The Wang CS central processing unit (CPU) is a high-performance VLSI processor that supports up to 16 terminals and 16 jobs concurrently in a multi-programming environment. The system offers data communications capabilities and an extremely low-overhead operating system. Designed for simplicity of operation and flexibility in system configuration, the CS can be easily adapted to meet each user's unique processing requirements.

As a further enhancement of the 2200 CS a modified version of the 2200 VLSI CPU/Memory PCB has been developed. The new version of the CPU/Memory PCB supports up to 8 Megabytes (MB) of user memory. All unused memory, memory not allocated to user partitions, is allocated to RAM Disk. The new version of the CPU/Memory PCB will be supported in all VLSI 2200 systems. This includes the CS, Micro/VP, and the MVP-128/512.

ECO NO. 48049D
SHEET 1 OF 11

FIGURE 2: 210-9558 DPU MOTHER BOARD (COMPONENT SIDE)

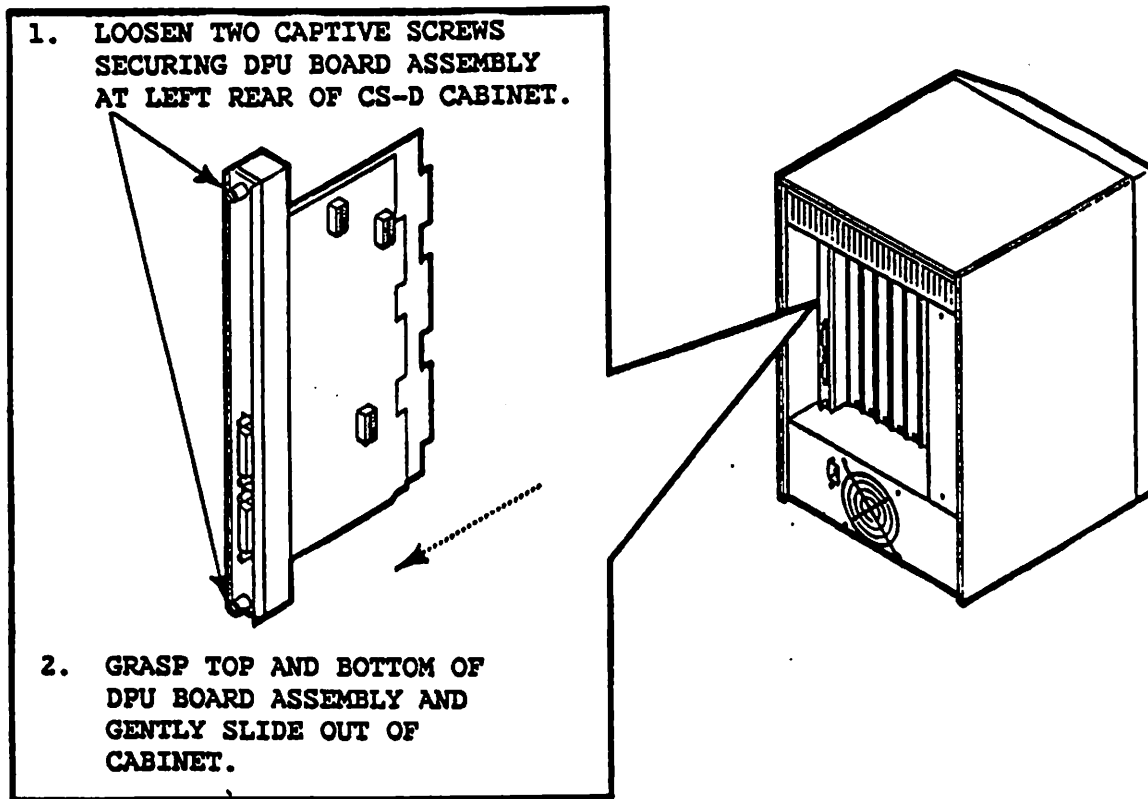
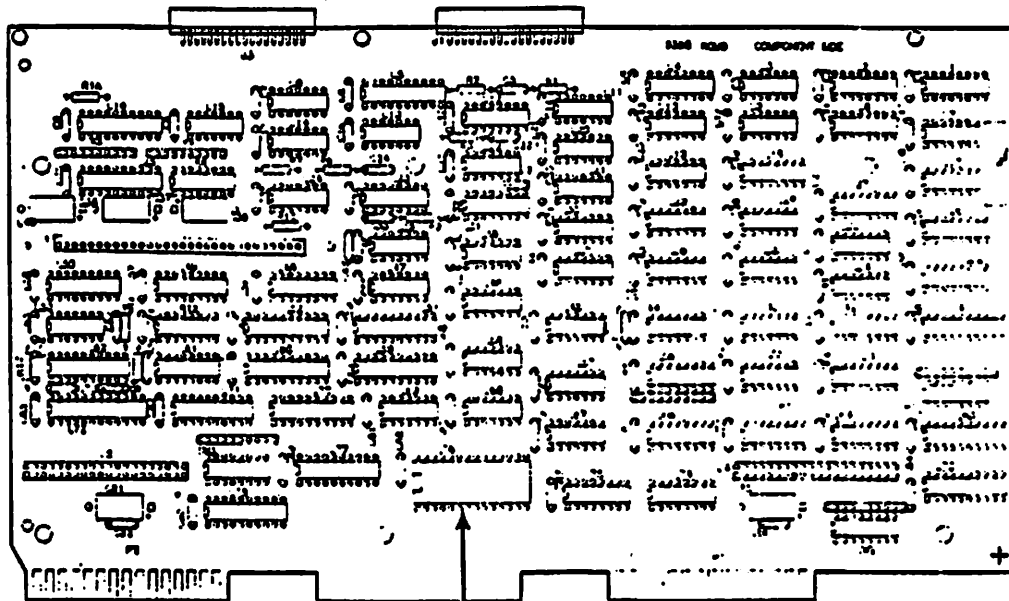
C. Rework the 210-9558 DPU Mother board as follows: (Figure 2)

1. Remove the E-PROM from location L76 and replace with E-PROM (379-8500-R3) contained in Kit.

REMOVE E-PROM FROM LOCATION L76
AND REPLACE WITH E-PROM (379-8500-R3)
CONTAINED IN KIT.

FIGURE 2: 210-9558 DPU MOTHER BOARD (COMPONENT SIDE)

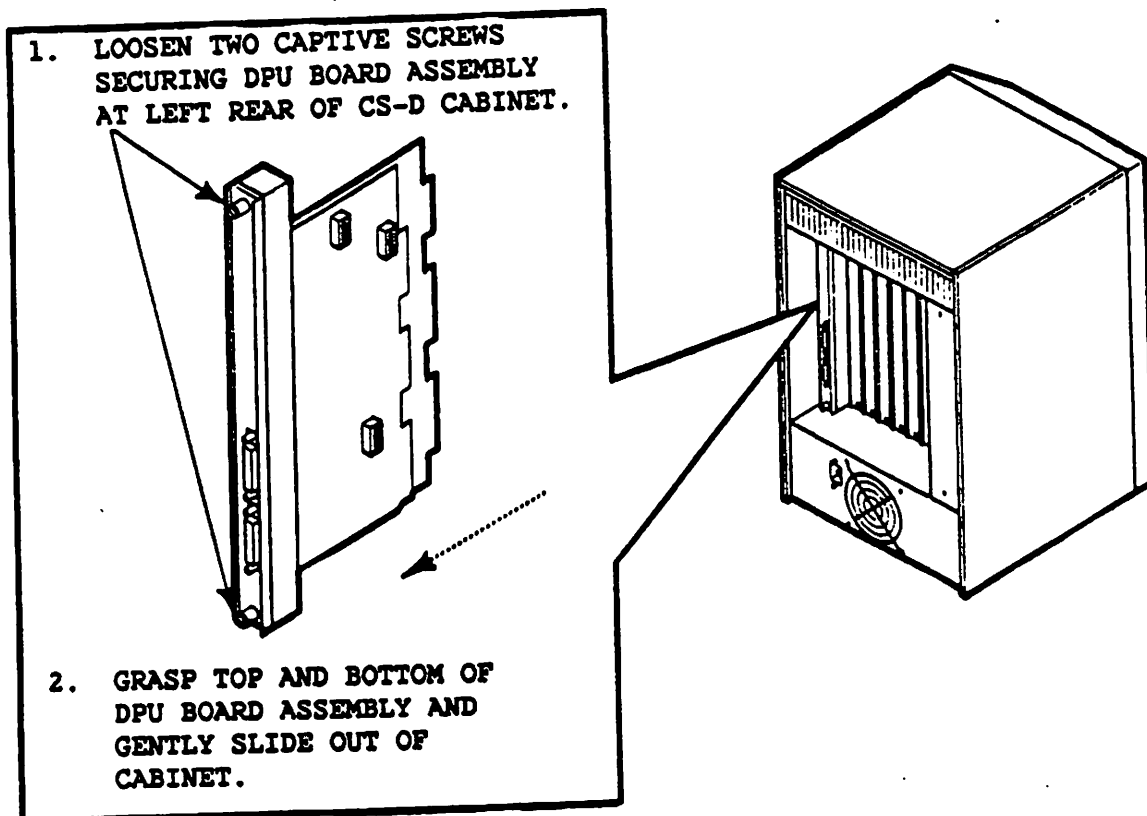
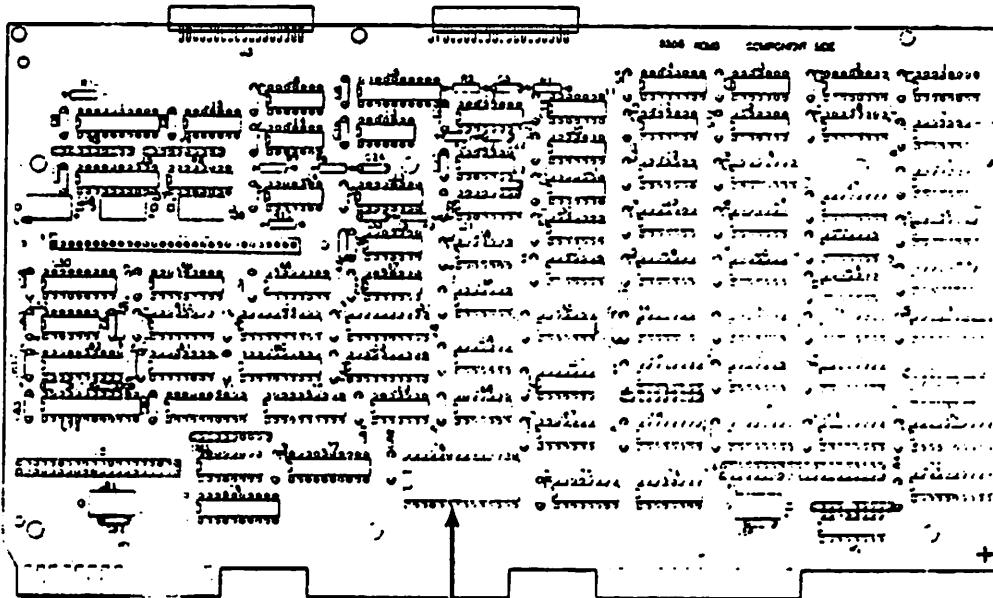
- C. Rework the 210-9558 DPU Mother board as follows: (Figure 2)
1. Remove the E-PROM currently in location L76 and replace with 379-8500-R2 PROM contained in Kit.

**REMOVE E-PROM CURRENTLY IN LOCATION
L76 AND REPLACE WITH 379-8500-R2 PROM
CONTAINED IN KIT.**

DWA B. S. RICHARDS		WANG LABORATORIES INC.	
CHK F. S. SANTOS		LOWELL MA USA	
ENG W.-C. CHUNG		TITLE	
DATE 2-8-89		MOTHER BOARD	
MODEL	CSD	PART NUMBER	210-9560
SHEET 1 OF 1	1	SIZE	E 9560
DRAWING NUMBER		REV

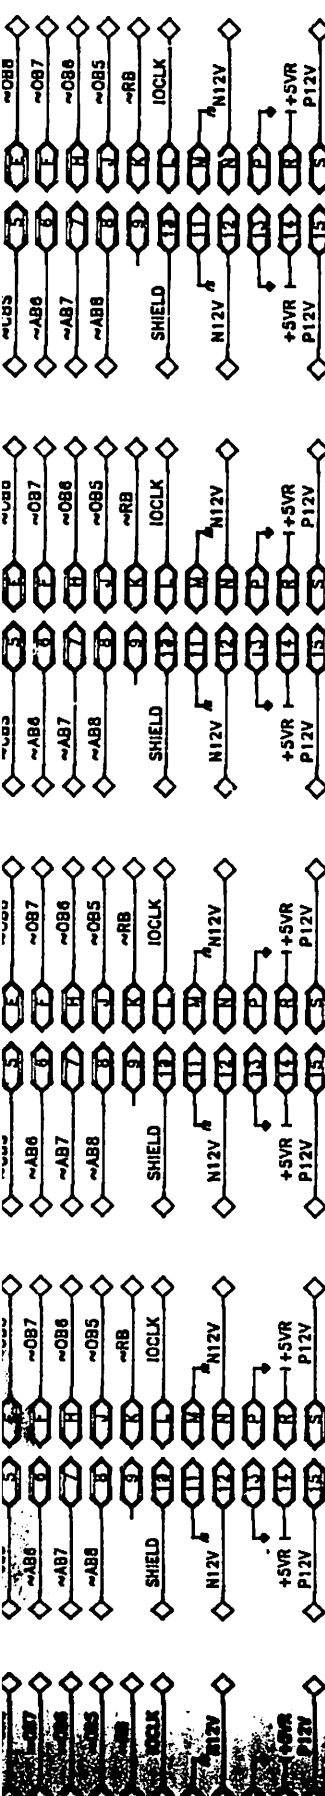
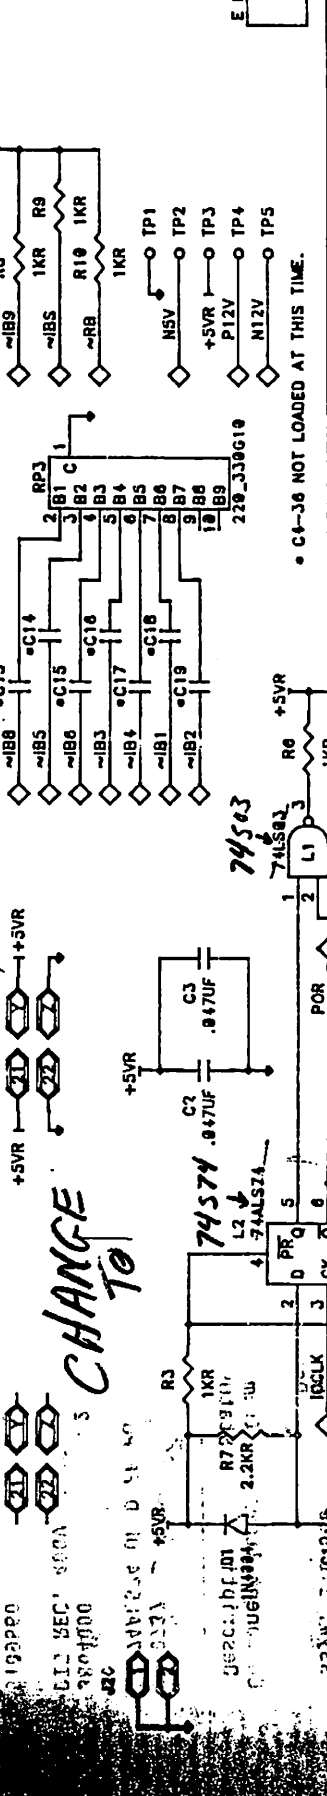
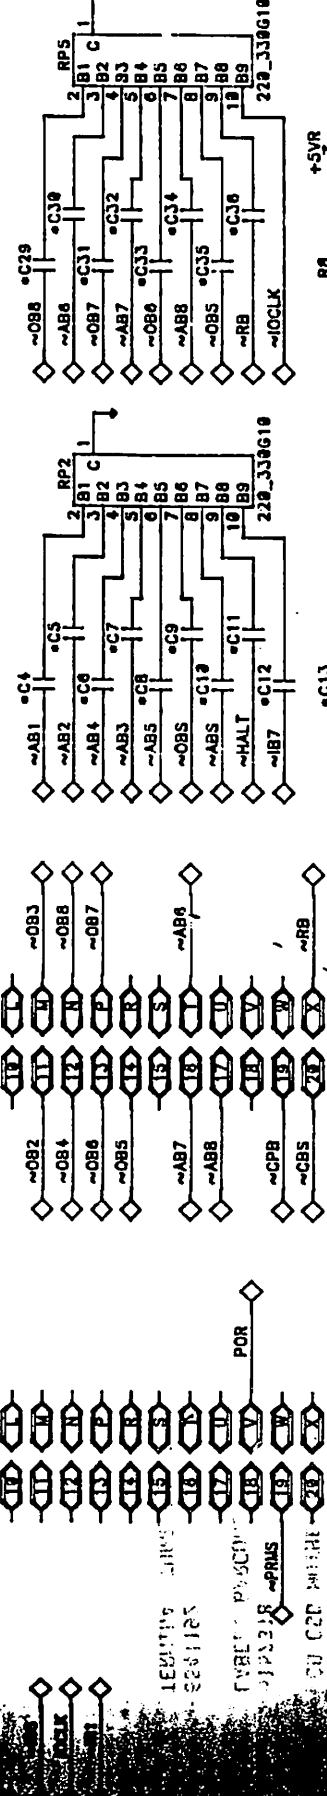
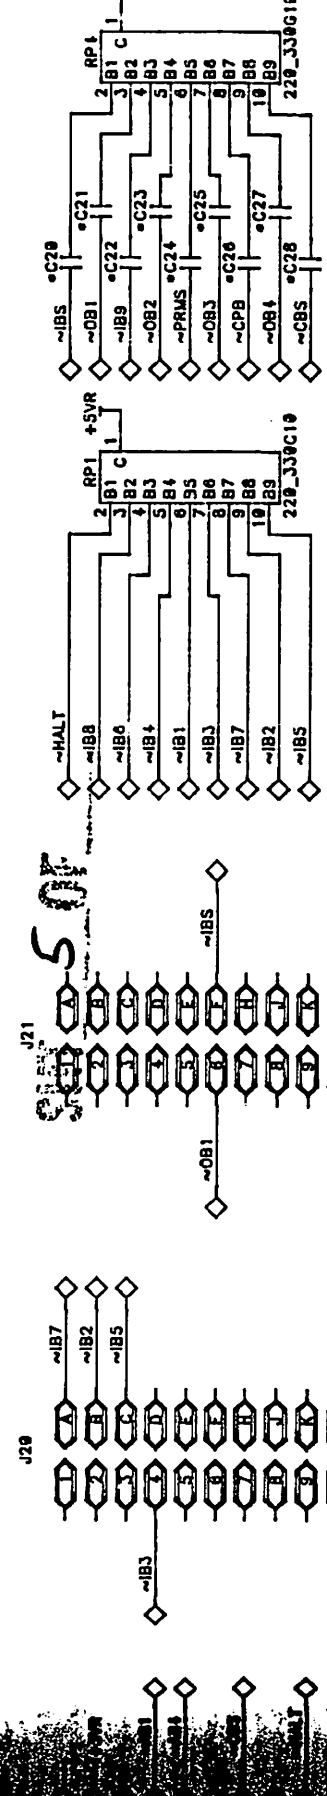
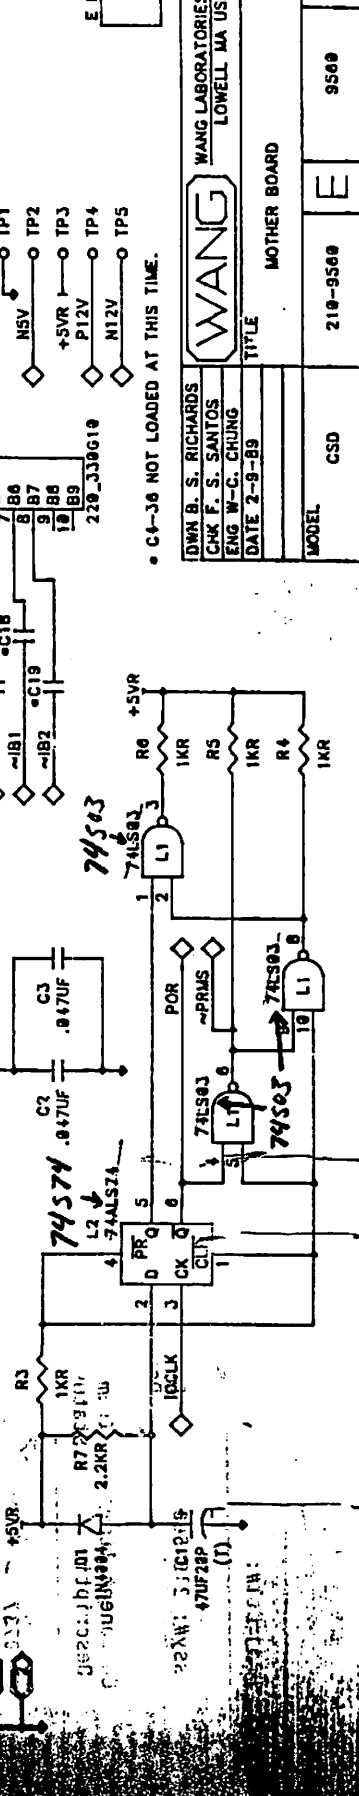
CHANGE TO

* C4-36 NOT LOADED AT THIS TIME.
